Planning Development Application Assessment Report

Application No:	DA 01-02-2015
Application Site:	Site 68, Bennelong Parkway / Australia Avenue, Sydney Olympic Park
File No:	F15/201
Proposal:	Construction of a single storey building, together with fitout and operation as a Child Care Centre
Applicant:	Ecove Group Pty Ltd
Determining Agency:	Sydney Olympic Park Authority

Figure 5 Ground Floor plan

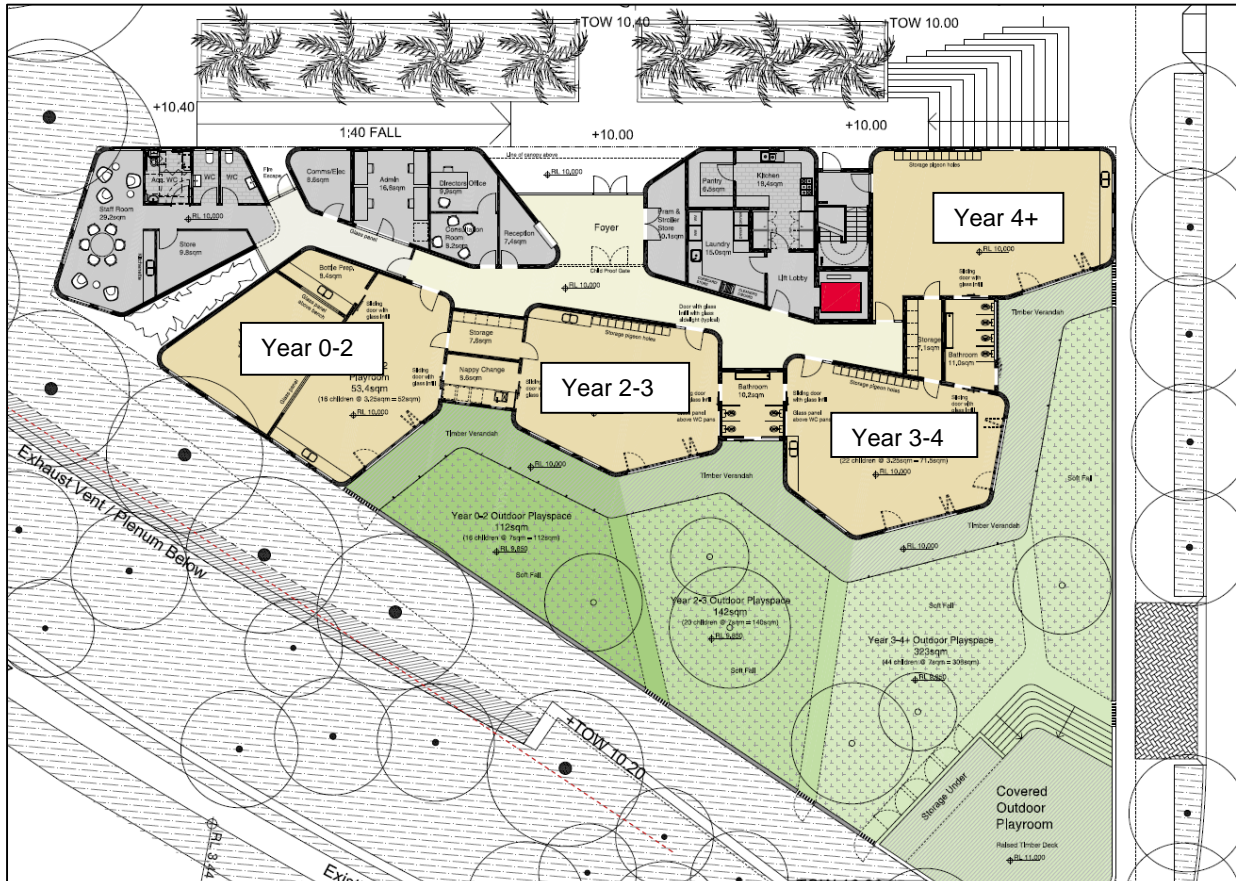
- Further information is required to confirm where double glazing will be located so as to appropriately mitigate against noise and provide suitable amenity for young children where required;
- The impact of the large car park exhaust vent shown at the south elevation on air quality of the child care outdoor play area has not been provided and further information is required to confirm the likely impact.

Additional information was sought in relation to the likely impacts on **air quality**. In this regard, the applicant has advised that whilst the car park exhaust extends almost the full

length of the site, it has been purposely designed to stop short of the child care centre outdoor play area.

In addition, the exhaust achieves a 6 metre minimum separation from the child care centre (and all other development on the site) in compliance with the BCA. The angle of the car park exhaust directs air away from the child care centre towards Bennelong Parkway, and the exhaust will operate on a sensor system rather than continually expelling air. Furthermore, the car park is primarily associated with a residential use, which typically will not generate the same level of exhaust as more intensive uses such as commercial, retail or public car park.

Having regard to the the above it is anticipated that impacts to the air quality in the vicinity of the child care centre will be minimal.
